DUKE COGEMA
STONE & WEBSTER

Subject: Docket Number 070-03098
Duke Cogema Stone & Webster
Mixed Oxide Fuel Fabrication Facility
Responses to the Request for Additional Information
on the Environmental Report

**RESPONSES TO
REQUEST FOR ADDITIONAL INFORMATION
FOR THE DUKE COGEMA STONE & WEBSTER (DCS)
MIXED OXIDE (MOX) FUEL FABRICATION FACILITY (FFF)
ENVIRONMENTAL REPORT (ER)**

Figure 37-1 Site Infrastructure Development Concept

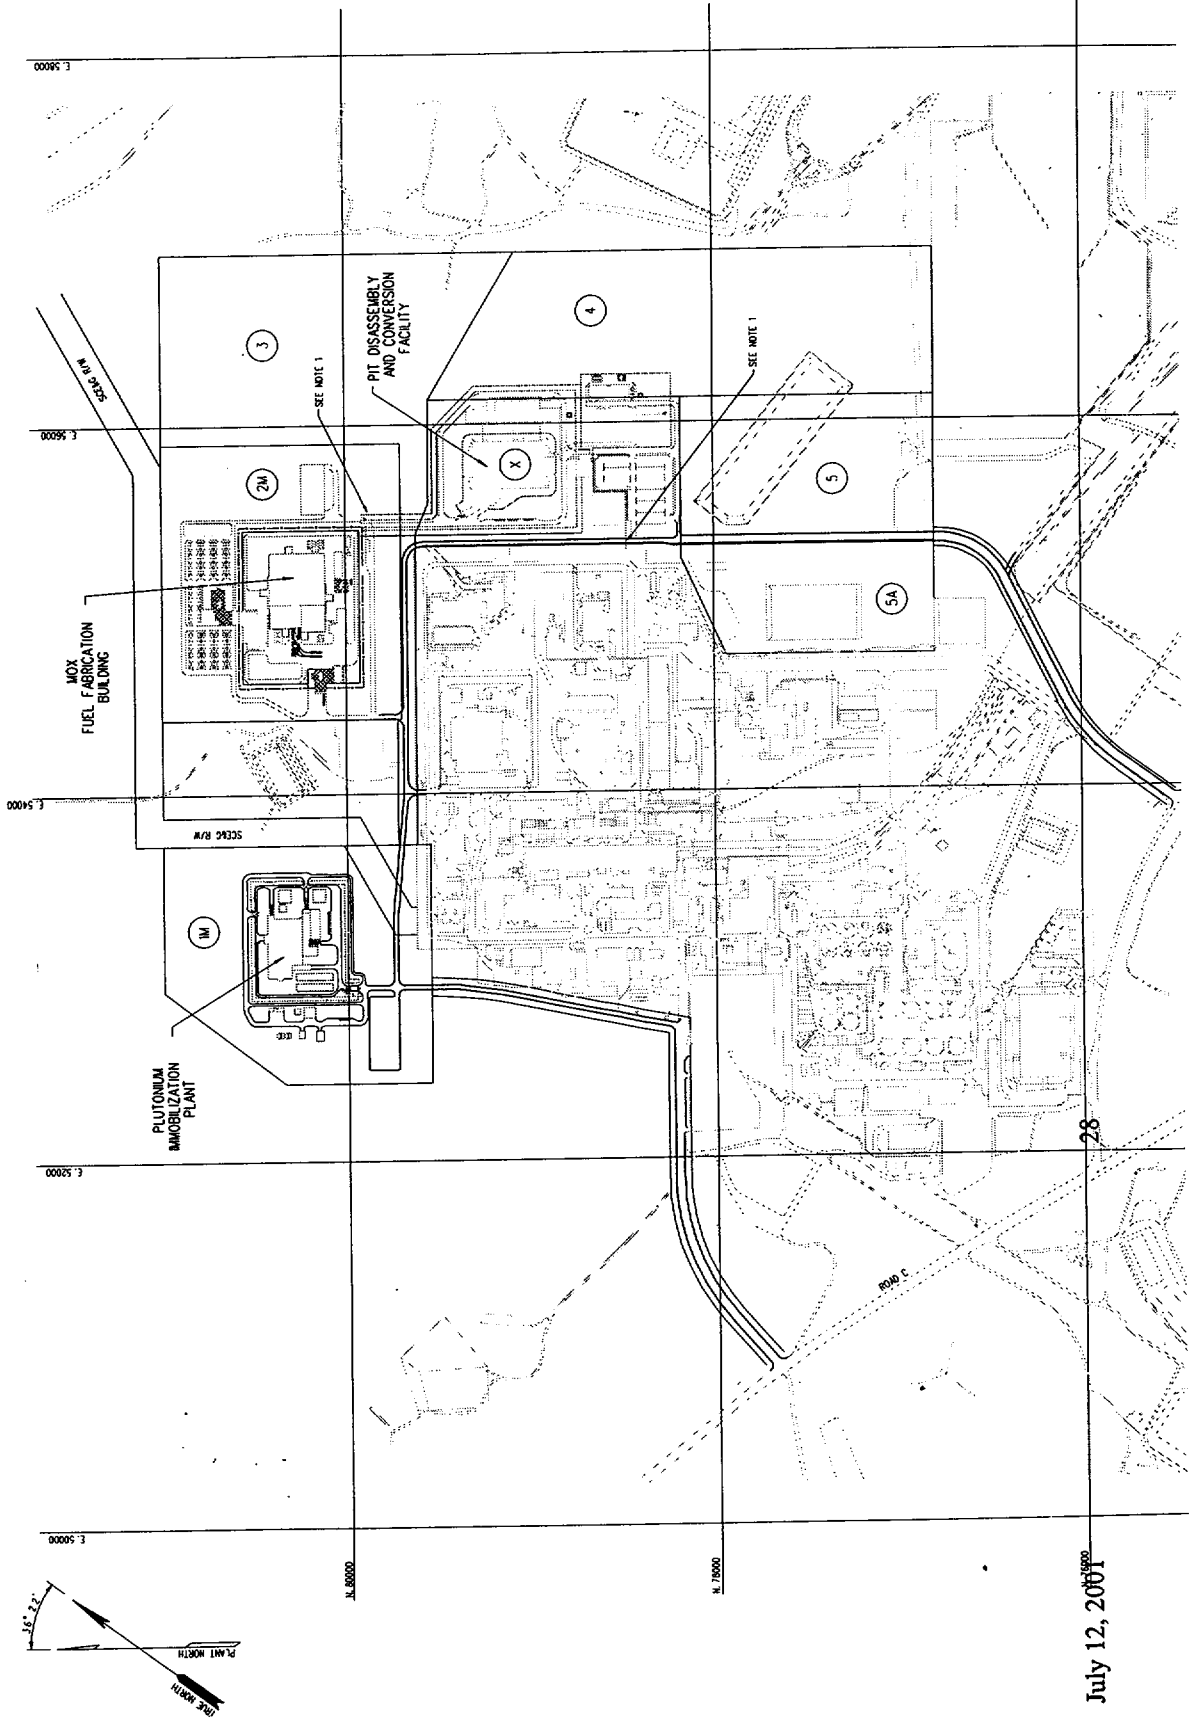
27. Section 5.1.11, Infrastructure. The statement is made in reference to infrastructure that "... upgrades include clearing and grading of all three sites, developing integrated stormwater flow patterns for all three sites, providing utility services to all three sites, and providing any new access roads". Details of these upgrades, particularly design and location information, are needed to support the impact assessment of areas disturbed during construction. How much land will be disturbed for new access roads needed for MOX FFF construction? Provide a map showing the approximate locations of new access roads. Also, provide the types of habitats these upgrades would be routed through.

Because only 1,300 to 1,500 feet of the proposed roadway (in two pieces) is not in previously cleared road rights-of-ways, the total land area expected to be disturbed in connection with road work is less than 5 acres. See attached Figure 27-1, Site Infrastructure Development Concept.

Road upgrades for ingress and egress to the MFFF site will be conducted in existing traffic rights-of-ways. Relocation of the South Carolina Electric & Gas power line, digital cable lines, telephone lines, and adjacent survey area includes flat sandy uplands, flanking slopes that transition to erosion ditches and a small stream bottom. Within these topographic areas, the following plant communities are noted; upland longleaf pine, successional mixed pine-hardwood, dry oak-pine slopes, mesic hardwood slope, moist-bottom mixed pine-hardwood forest and a series of early successional systems. Assessment of the general ecological conditions and potential wetland areas for the proposed plutonium disposition facilities found no wetland areas within proposed construction site, no endangered or threatened species and no rare or unique ecological resources.

Utilities for the PIP, MFFF and PDCF will generally be routed along the existing F-Area Limited Area perimeter roadway – to the east and to the north of the road. This corridor also contains existing steam lines. The design of the utilities routing is still at the conceptual phase and will be developed in more detail with each facilities' design effort.
